# PRODUCT CHANGE NOTIFICATION

## Bourns® Model 7400 Series Common Mode Choke Marking Process Change

### *Change from Ink Marking to Laser Marking*

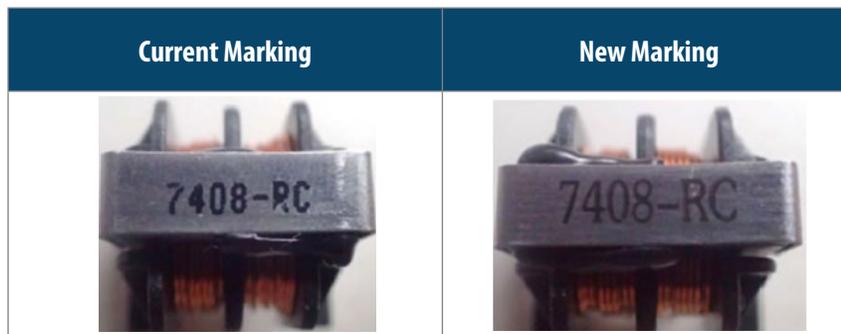
Riverside, California – October 8, 2019 – Bourns is changing the marking process of the [Model 7400 Series Common Mode Chokes](#) from ink stamping to laser printing. The new process will increase manufacturing productivity and improve marking durability. A list of affected part numbers is shown below.

The laser marking process will have no impact on the fit or function of the product. The form will change due to the appearance of the marking. The quality and reliability should be improved as the result of the process change.
